**MINIARY GEOTECHNICAL INVESTIGATION
GRANDVIEW RESERVE
STONVILLE ROAD AND U.S. HIGHWAY 24
FALCON, COLORADO**

Soils & Geology Report_V1.pdf Markup Summary 10-26-2021

FIG. 1 – LOCATIONS OF EXPLORATORY BORINGS..... 10

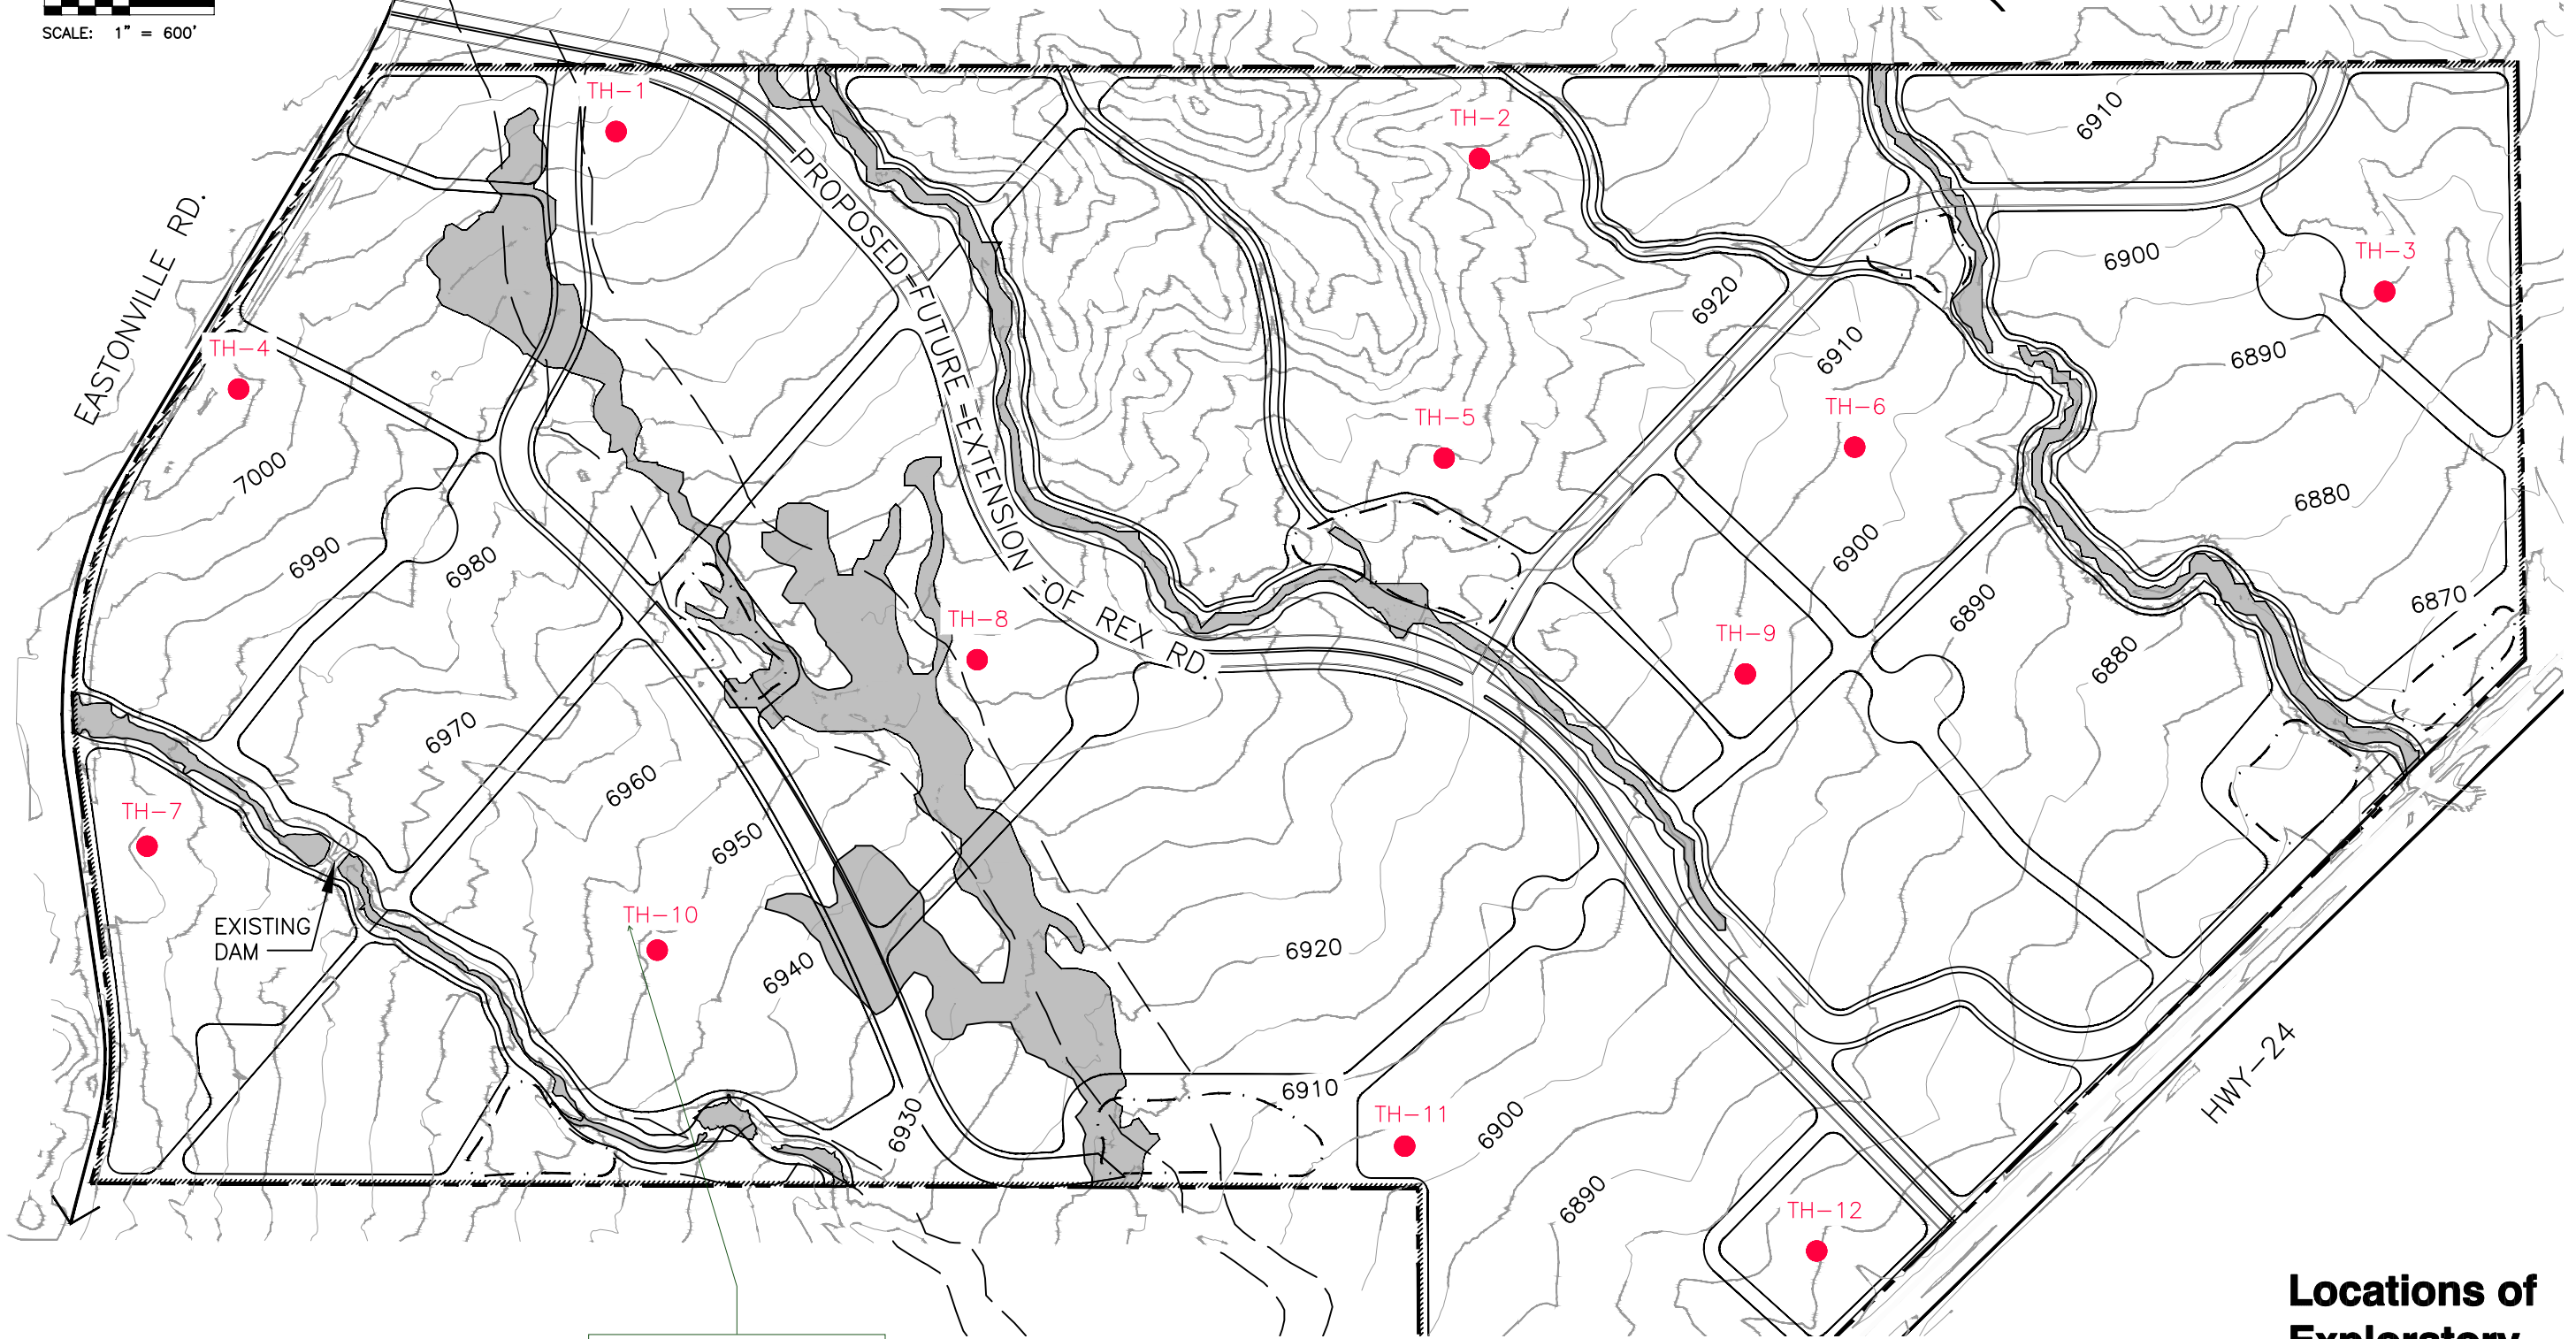
floodplain hazards

missing several borings
